Service Bulletin

SUBJECT: Service Update for Inventory and Customer Vehicles
Contact between the Fuel Feed Line and the A/C Pipe
Expires with Base warranty

MODELS: 2013 – 2014 Chevrolet Trax with 1.4L Turbo engine

4004602

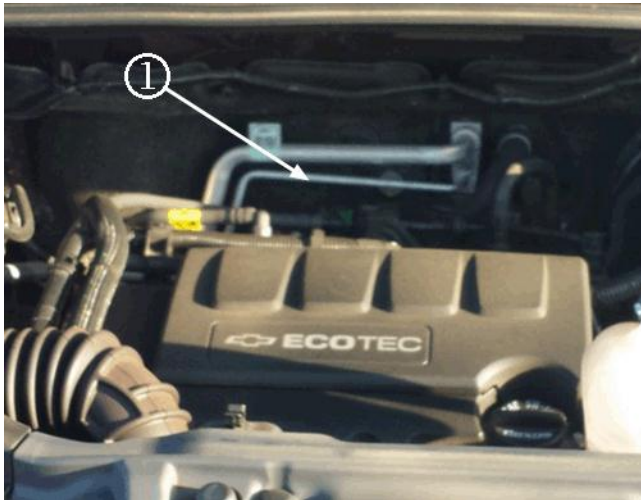
- b. Locate the A/C pipe (1) for inspection.
- c. Inspect the A/C pipe section (1) that is adjacent to the fuel hose (2):
 - i. If the A/C pipe does not show any sign of wear or damage, proceed to step 2.
 - ii. If the air conditioner pipe is worn or damaged, replace the A/C line, refer to *Air Conditioning Evaporator Hose Assembly Replacement Procedure* in SI.

4004608

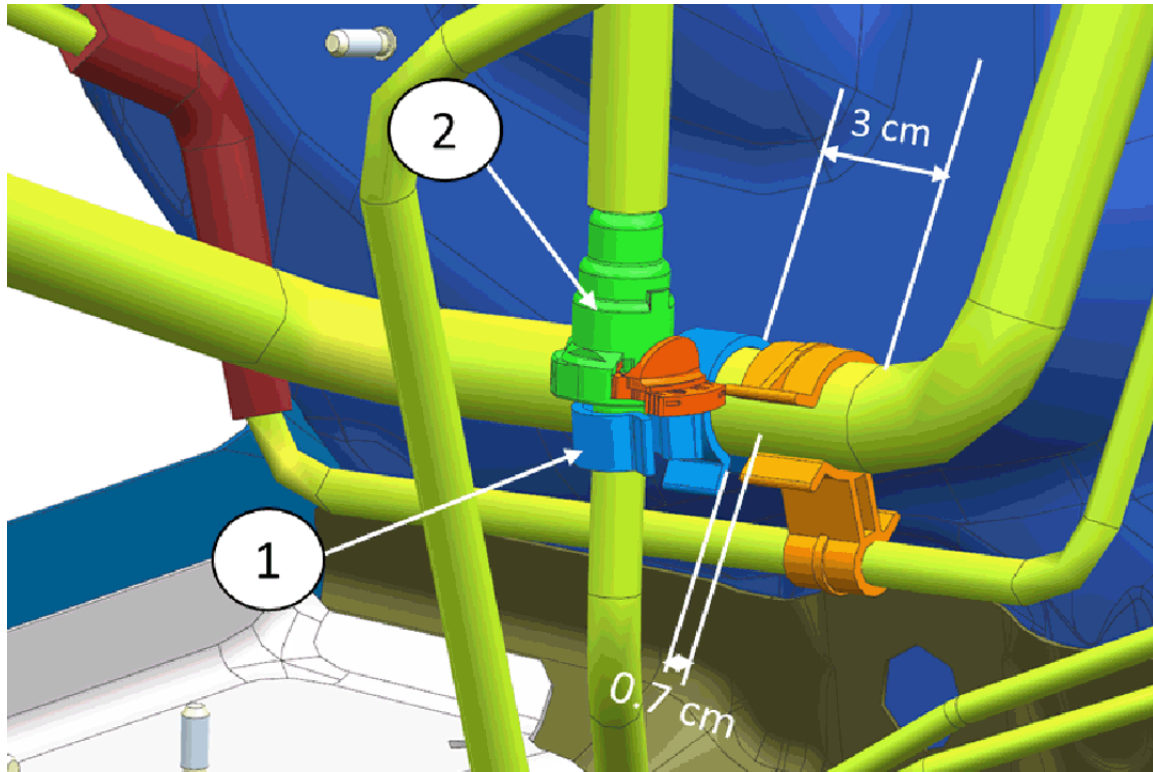
- a. Install the swivel clip (1) underneath fuel hose quick connector (2) as pictured above.
